ALERT SERVICE BULLETIN

430-14-54
10 November 2014

SUBJECT: GOODRICH EXTERNAL HOIST

Equipment/Furnishings - Load Check Inspection - Safety and Reliability

Figure 1. Acceptable Range for the 600 lb capacity hoists

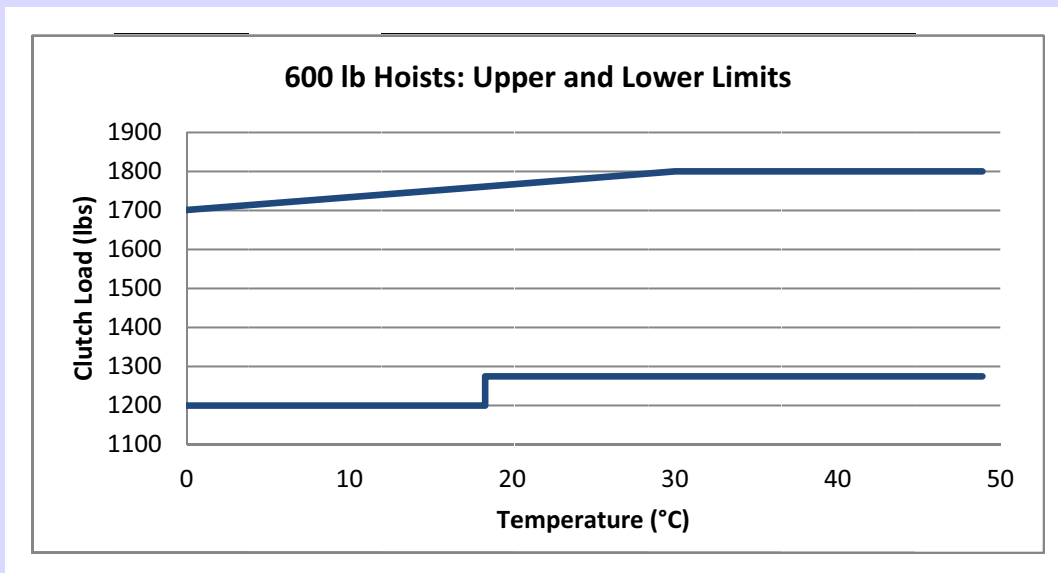
PAGE NO.	DESCRIPTION OF CHANGE	EFFECTIVITY
1	Updated Table 1 to refer to Tables 2 and 3 for upper load check limits.	All
2-3	Added Tables 2 and 3. Following tables renumbered.	All
6	Changed compliance requirements	All
7	Revised note Revised information recorded Revised table	All
8	Revised 44301-10-4 usage	All
9	Added note	All
11	Added note about controlled environment Revised note to add maximum load	All
12	Added additional information about evaluation of test results	All
13	Added Figure 4	All
14	Revised actions following testing failure	All
16	Revised reporting form	All

Hoist Family	Slip Load (Lb)		
	Low temp 32-64°F (0-18°C)	Normal temp 65-85°F (18-30°C)	High temp 86-120°F (30-50°C)
42315	1200-see Table 2/Figure 1	1275-see Table 2/Figure 1	1275-1800
42325	1200-see Table 2/Figure 1	1275-see Table 2/Figure 1	1275-1800
44301-10-4, -7, -9, -12, -13	1200-see Table 2/Figure 1	1275-see Table 2/Figure 1	1275-1800
44301-10-1, -2, -5, -6, -8, -10, -11	1000-see Table 3/Figure 2	1040-see Table 3/Figure 2	1040-1500
44311	1200-see Table 2/Figure 1	1275-see Table 2/Figure 1	1275-1800
44312	1200-see Table 2/Figure 1	1275-see Table 2/Figure 1	1275-1800
44314	1200-see Table 2/Figure 1	1275-see Table 2/Figure 1	1275-1800
44315	1200-see Table 2/Figure 1	1275-see Table 2/Figure 1	1275-1800
44316	1200-see Table 2/Figure 1	1275-see Table 2/Figure 1	1275-1800
44318 (except 44318-11-103)	1200-see Table 2/Figure 1	1275-see Table 2/Figure 1	1275-1800

TABLE 2. Upper Load Limit, 600 lb hoists
